# Superfund Record of Decision:

## Selma Treating, CA

RECORD OF DECISION  
FOR THE  
SELMA PRESSURE TREATING COMPANY  
SUPERFUND SITE

PREPARED BY  
THE U.S. ENVIRONMENTAL PROTECTION AGENCY  
REGION IX  
SAN FRANCISCO, CALIFORNIA

**Figure  
5**

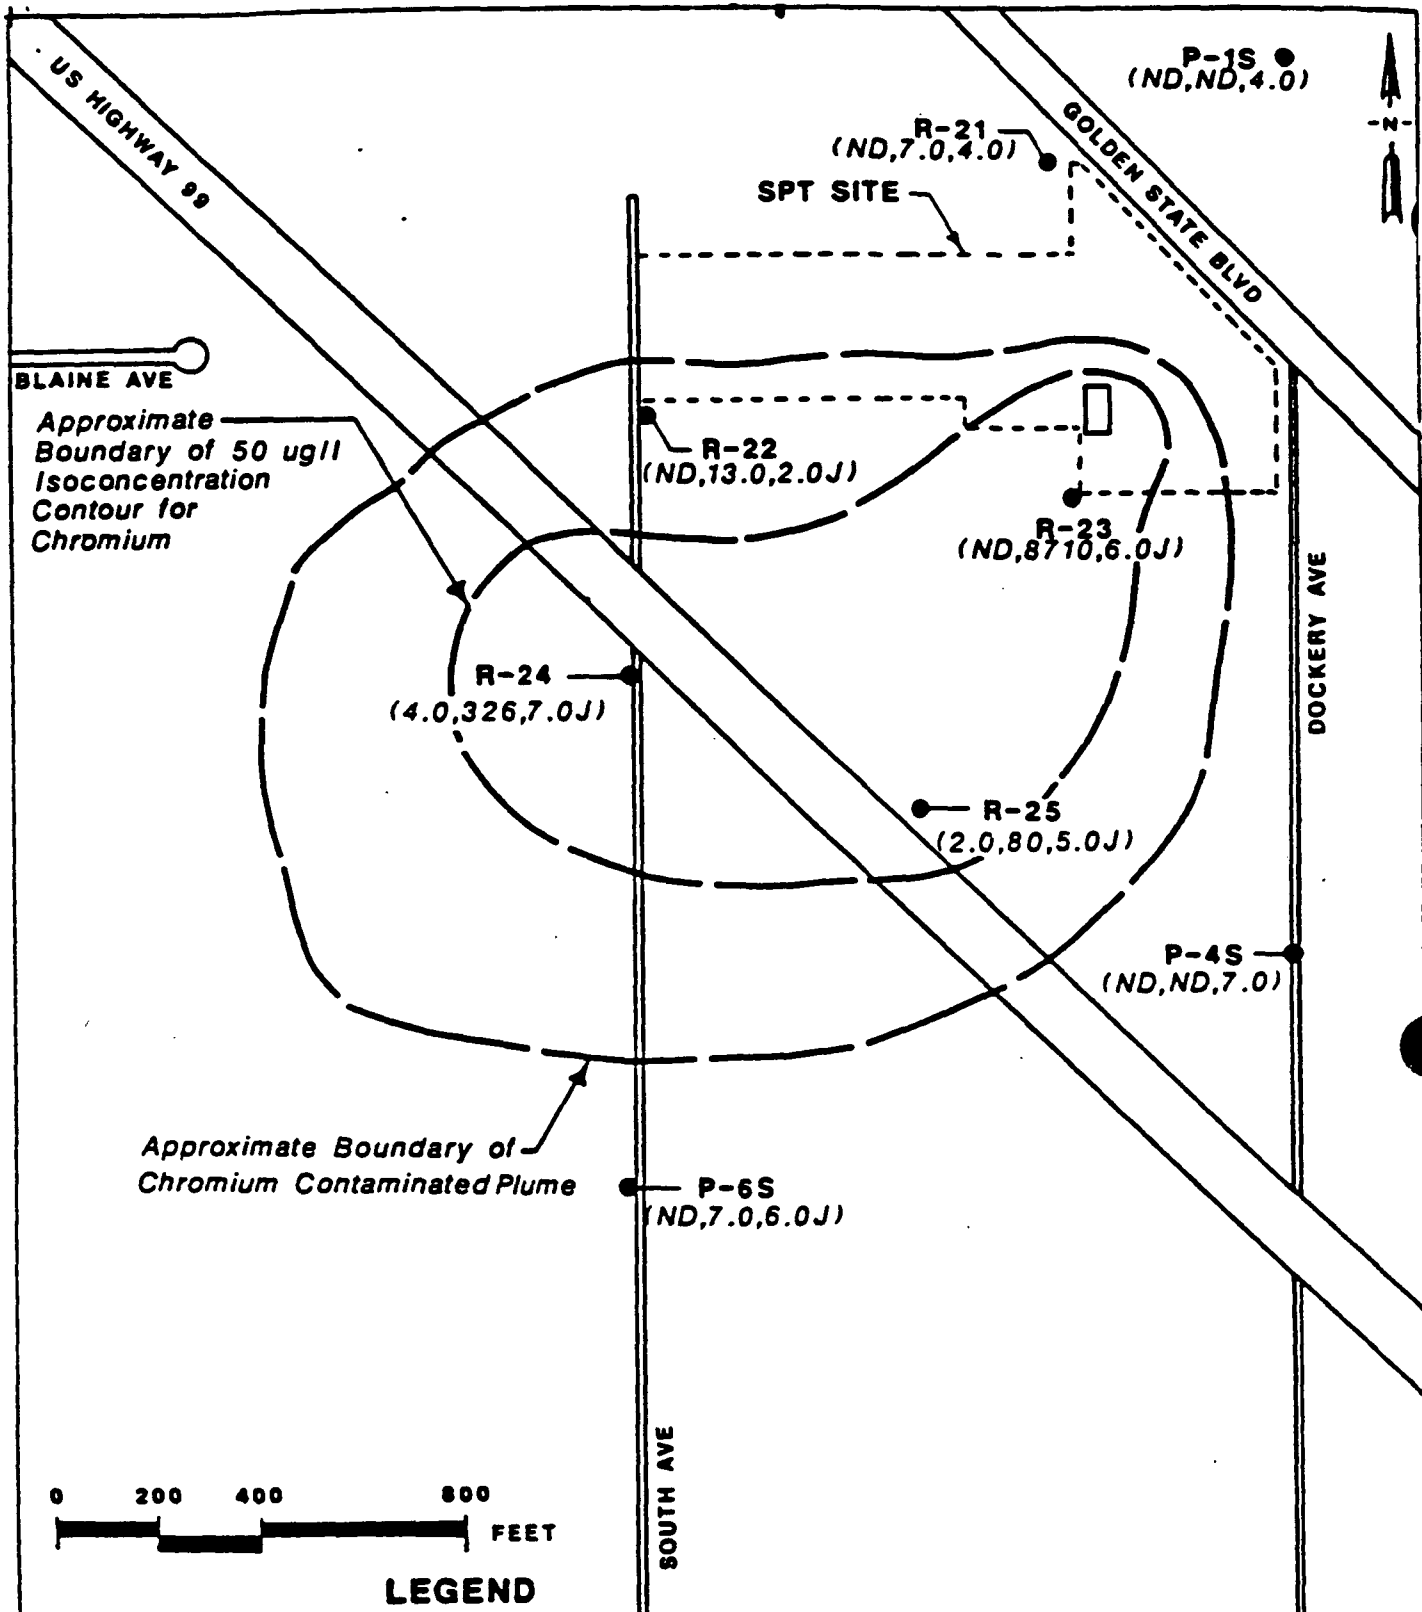
Sampling results indicate that a chromium contaminated plume extends downgradient from the site to the southwest (Figure 5). The southern boundary of this plume appears to range approximately 1,200 feet south-southwest of the existing wood treatment facility boundary. The groundwater contamination is apparently confined to

The extent of the chromium contaminated plume needs additional definition to the west and southwest of well R24. As part of remedial design, two well nests west and south of R-24 are planned. A well nest will consist of one shallow well (40') and one intermediate well (60').

The boundary of the groundwater plume exceeding the chromium clean-up goal is delineated in Figure 5. This boundary was based on the elevated chromium values observed in the shallow monitoring and plume tracking wells. The western extent of contamination was estimated, based on the observed trend of the plume in other areas. The extent of contamination in this area will be further defined during the RD phase, through the installation of additional monitoring wells, as discussed in the preceding section.
